Planning Commission

Regular Meeting Agenda

Frances Meaders Council Chambers
151 Willowbend Road
March 9, 2026 | 6:30 PM

SUBJECT: Landscape Plan, MEJA Construction Inc., 407 Dividend Drive

SHEET NUMBER
LS 1.0

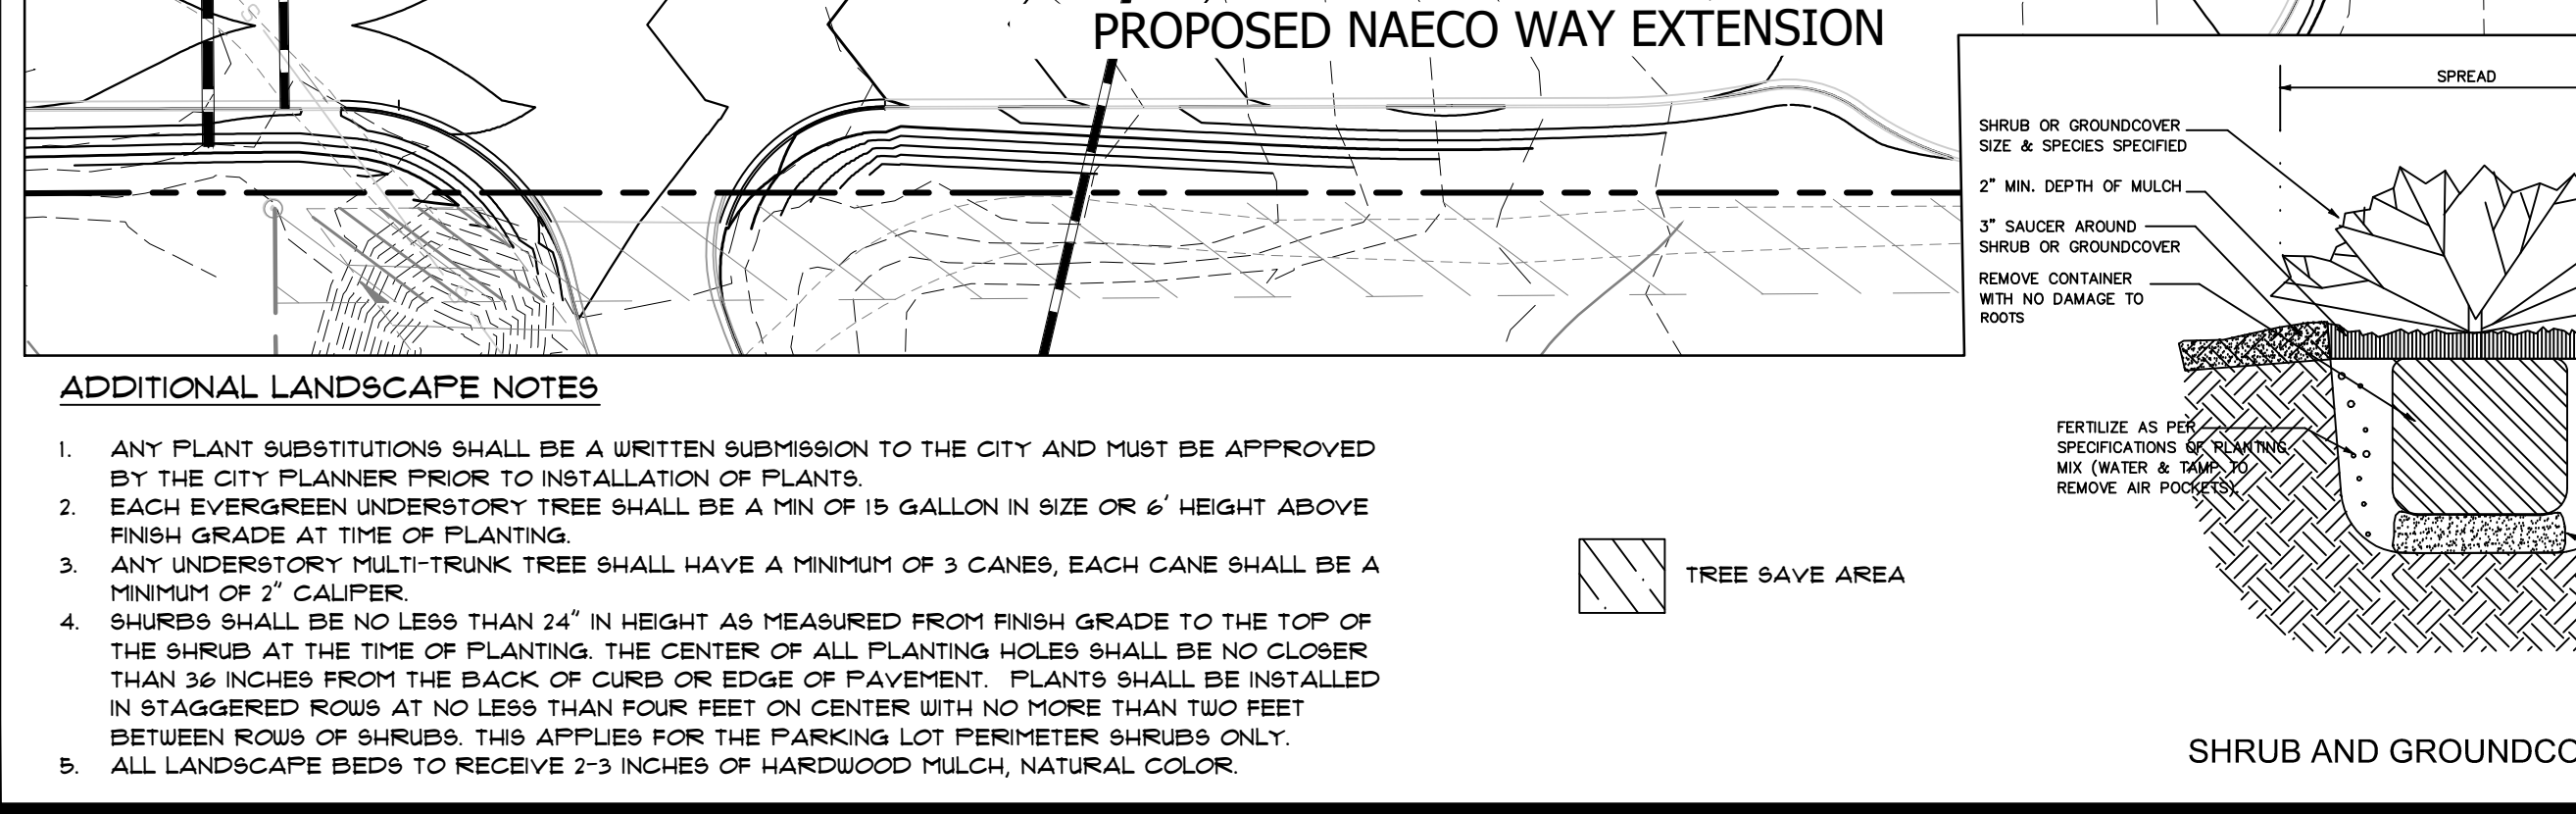
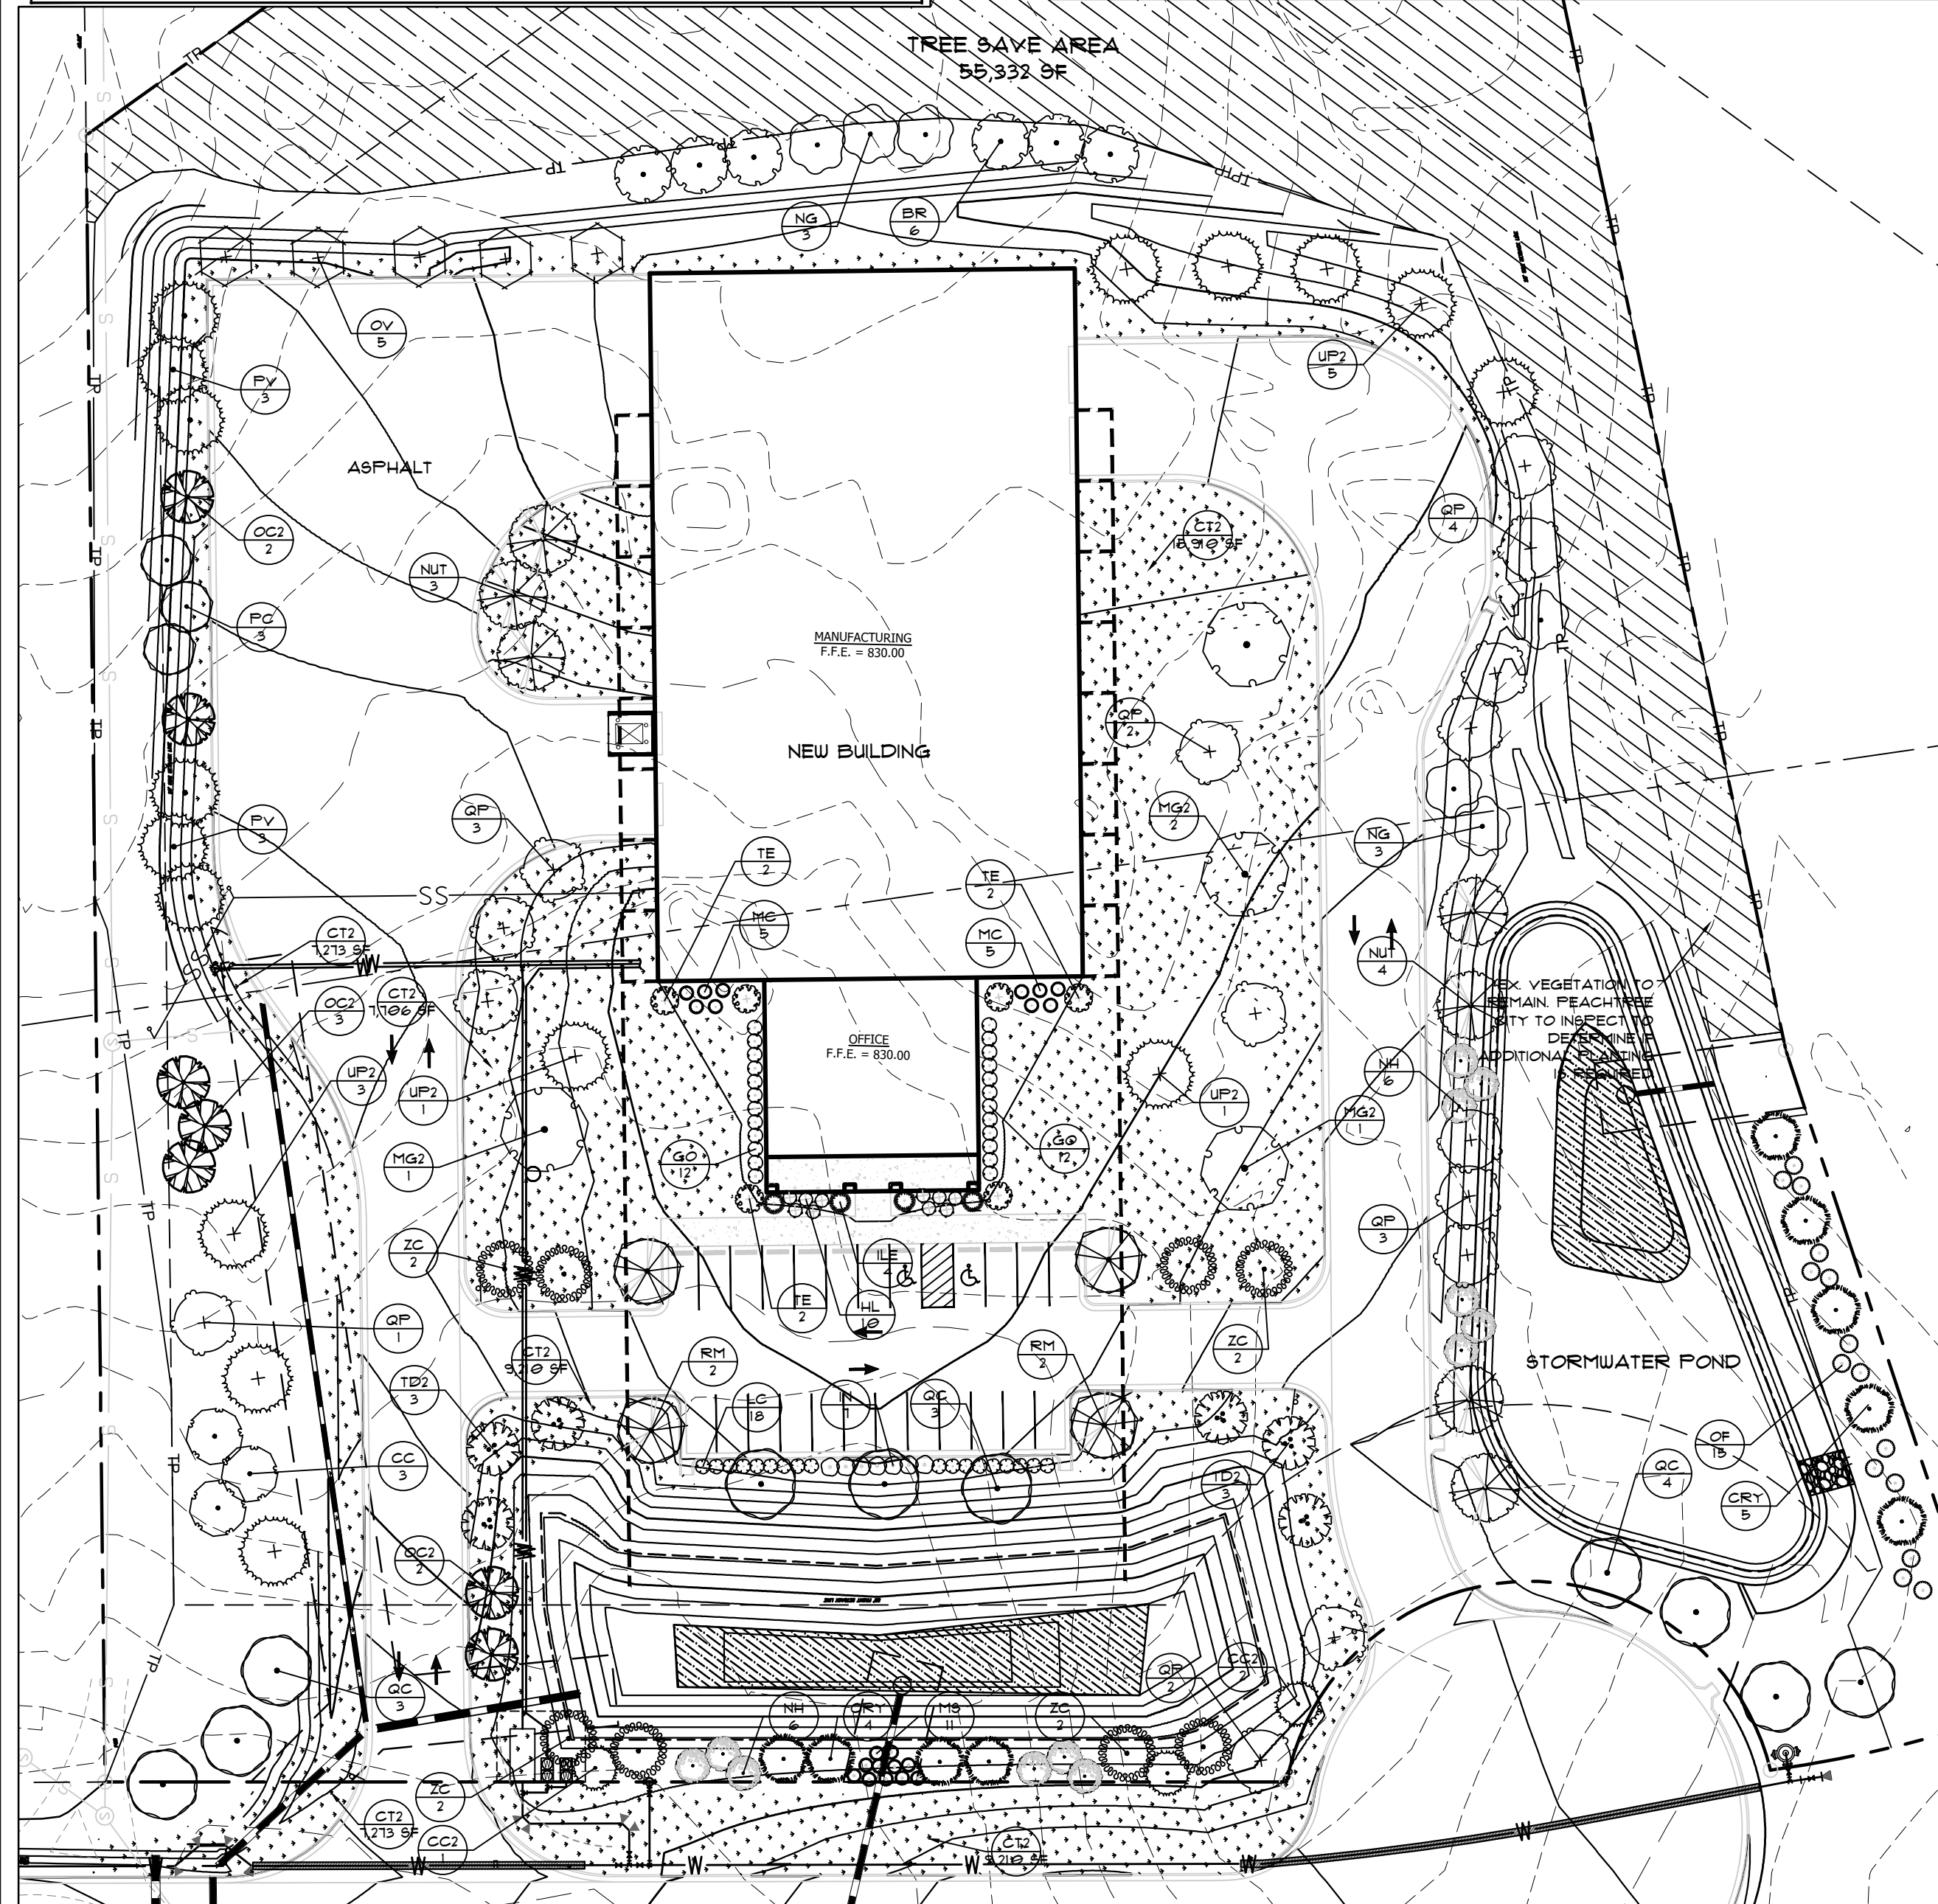
As part of the ordinance requirements, planting areas shall be located in front and on the sides of all retail, commercial and industrial buildings, wherever practical. The proposal includes landscaped area around most of the perimeter of the building with a shrub border highlighting the office portion of the building, thus satisfying this requirement.

In addition, the perimeter of all parking lots shall be landscaped with evergreen shrubs for screening of cars and headlights. The shrubs shall be no less than 24 inches in height at the time of planting. While the small parking area is separated from Naeco way by a detention pond and a tree border, the applicant is proposing a combination of two evergreen shrubs along the front edge of the parking lot.

Finally, all parking islands shall be 100% landscaped with canopy trees, understory trees, evergreen shrubs, and/or groundcover in mulched beds. The small parking lot does not contain islands.

Of the total number of trees provided, 50% are native to the eastern United States and/or the southeastern United States.

Staff believes that the proposed landscape plan for 400 Naeco Way meets the city's landscape ordinance. Should the Planning Commission decide to approve the plan, staff has no recommendations.

DRAWING NO. CP-01

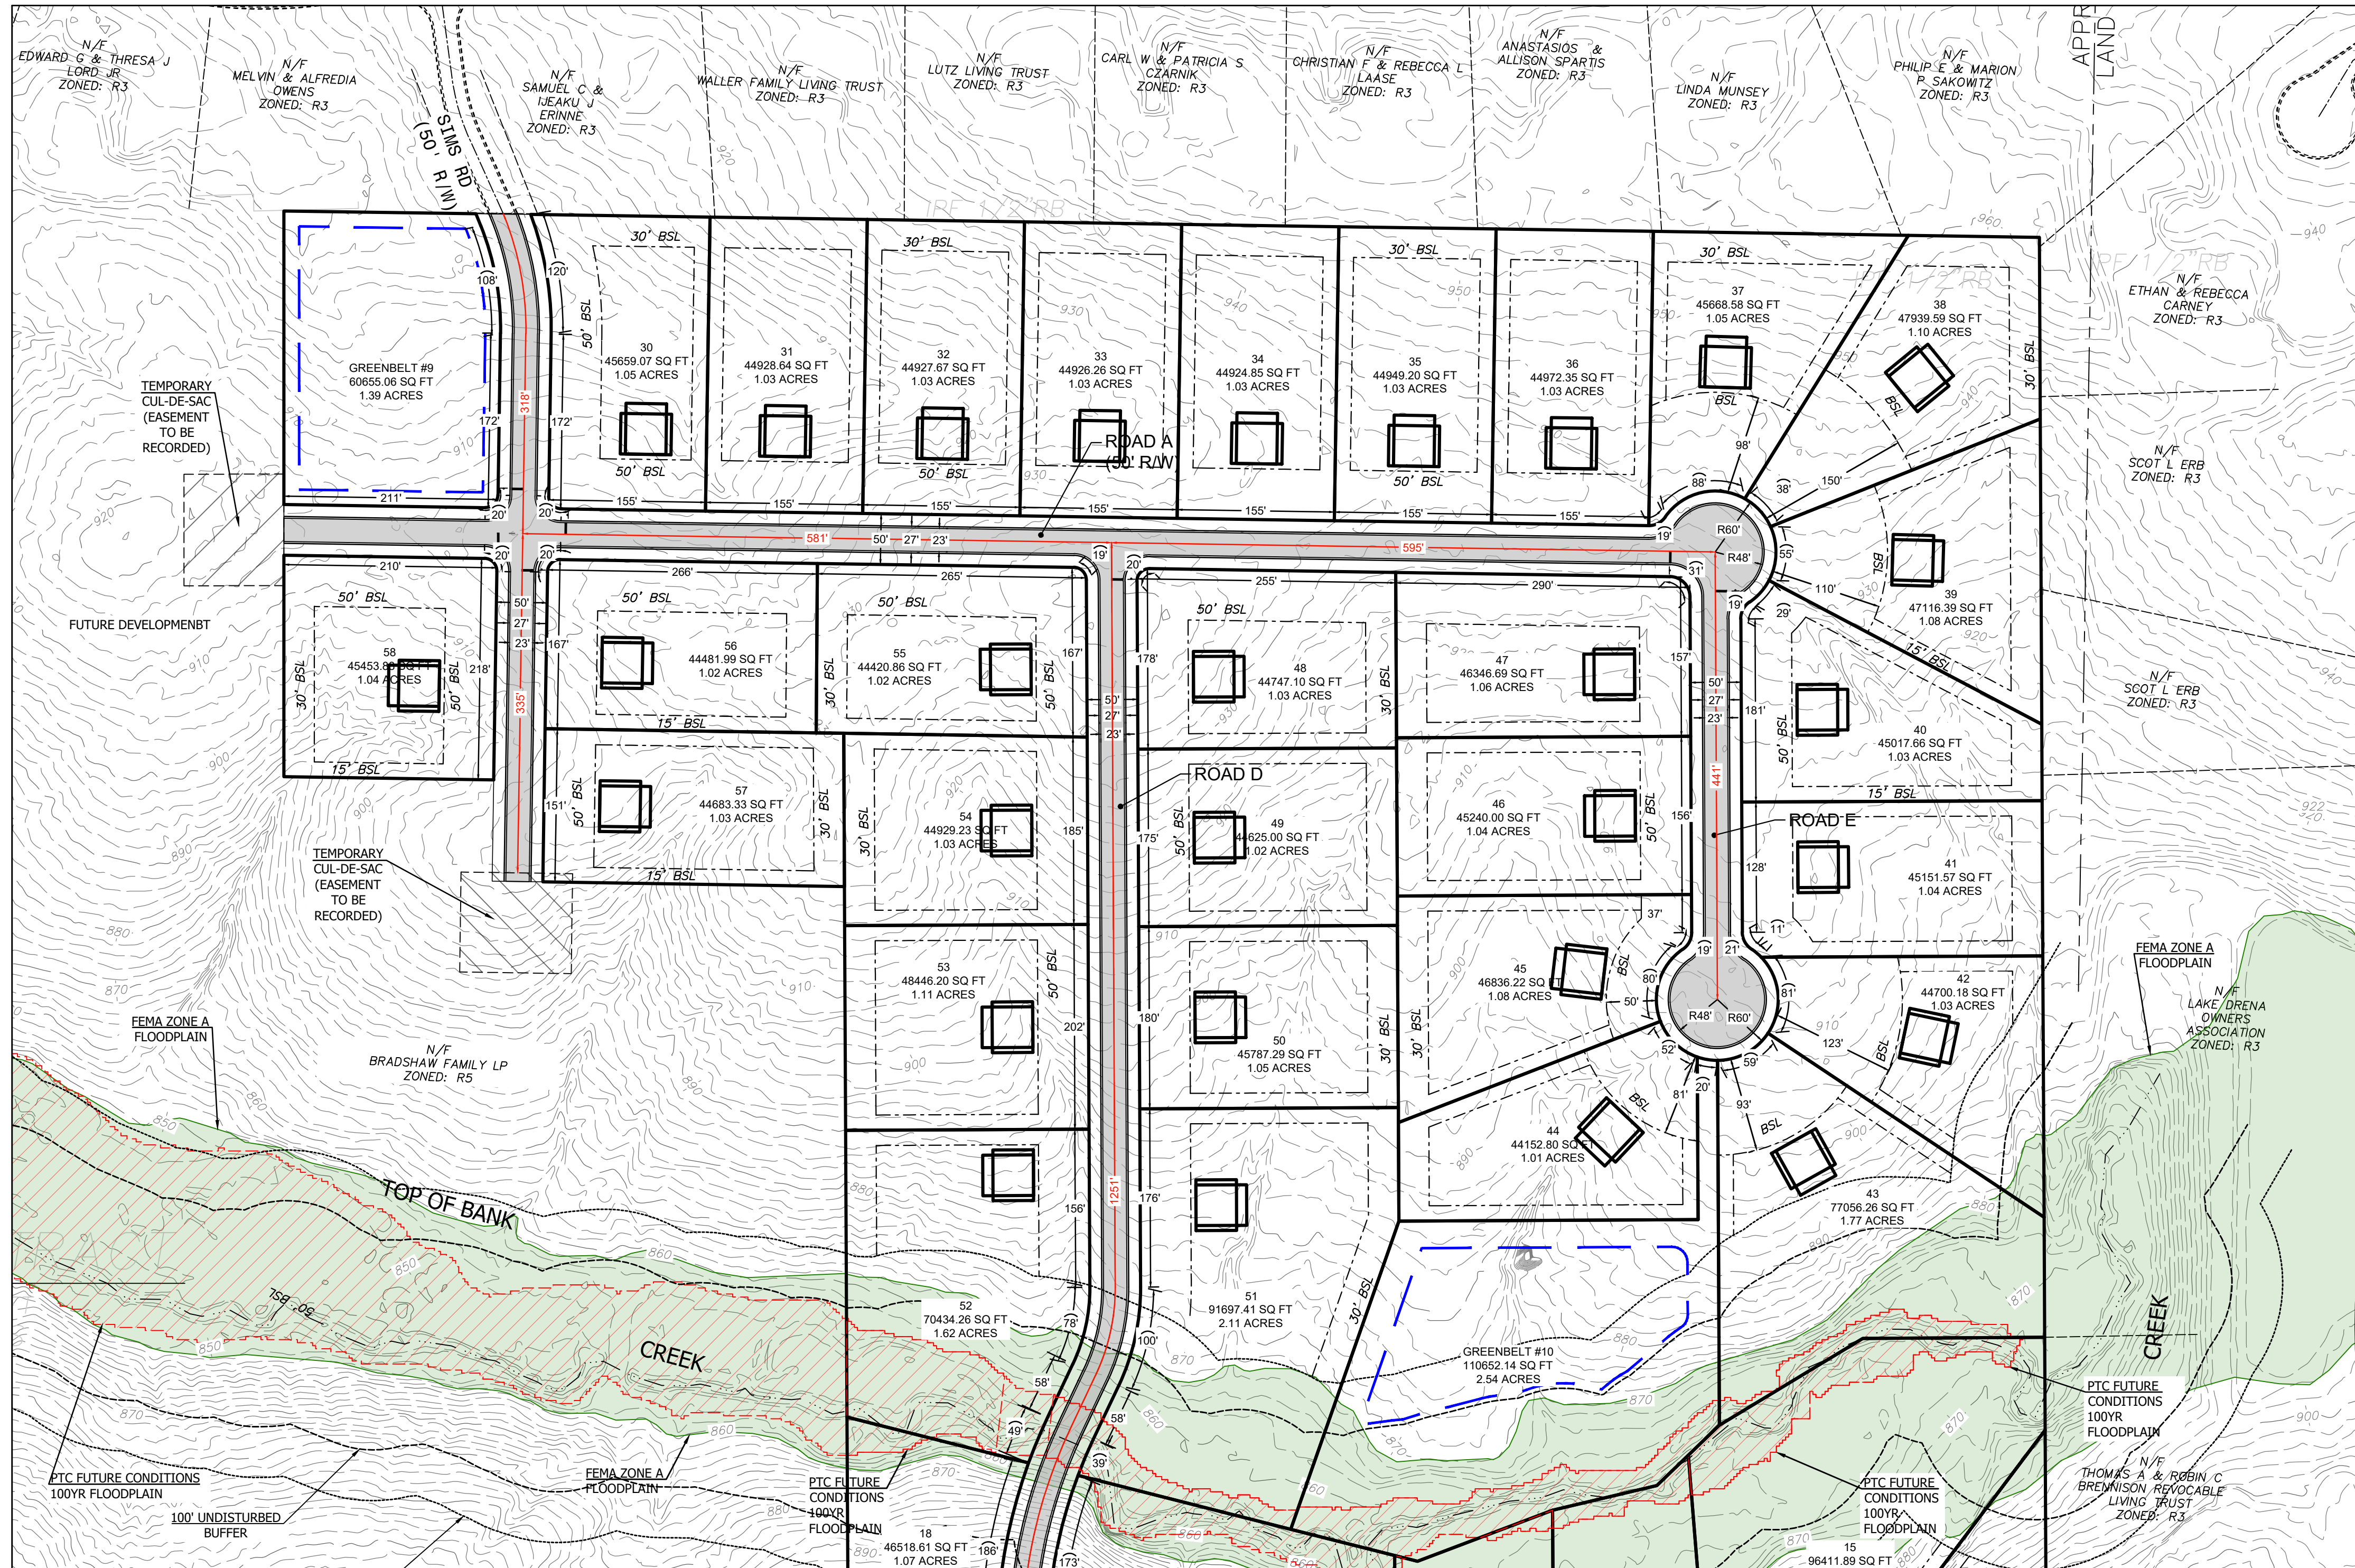
I am a resident of Peachtree City residing at **515 Ashley Way**, directly adjacent to the proposed subdivision on **Parcel 0720 001**. I am writing to express significant concerns regarding the current concept plan, specifically the layout of **Proposed Lots 1-5** and the **new internal road** located immediately behind the existing homes on Ashley Way.

The concept plan shows extensive clearing along the shared property line behind Ashley Way, including the removal of mature tree stands that currently function as:

This configuration would create **reverse-frontage lots** for the Ashley Way homeowners, which is exactly the condition Section 903 is intended to prevent.

- require the applicant to **revise the Concept Plan** to eliminate this reverse-frontage condition, **and**
- establish a **meaningful buffer and tree-save area** between any revised new street and the existing Ashley Way properties to mitigate the conflict with Section 903’s design principles.

As part of the PTC ordinance requirements, **(DM comments)** (Has the) “planting areas” **(DM comments)** been identified for this development along with locations, “wherever practical”. **(DM comments)** The proposal includes planting areas for the exterior perimeter?, “to satisfy this requirement”. **(DM comments)** The community lot does not stipulate the planting for screening most of the community parking lot from the neighboring properties and prevent headlights from shining onto those properties.

Section 1130(j) of the LDO states that “every Platted residential lot within the city shall plant and/or maintain no less than two trees at least two inches in diameter within the boundaries of the subject lot.” **(DM comments)** The southern lots currently have a tremendous number of trees greater than fifteen inches in diameter. With the removal of numerous trees in this concept proposal the residential lots are only required to replace these numerous trees, with only five caliper inches of trees for each

(DM comments) Lots 6, 7, and 8 will be exposed to erosion due to the water flow based on the terrain evaluation change from current yards of 120, 130, 140, and 150 Sedgewicke Drive. In addition, it is important to mention there are over 5 trees on top of my property at 150

In addition, the concept Platt does not indicate an erosion plan for the wetlands, flood prone areas, flood plain, and the creek on the north side of the 29 parcel Platt. Will this be addressed?
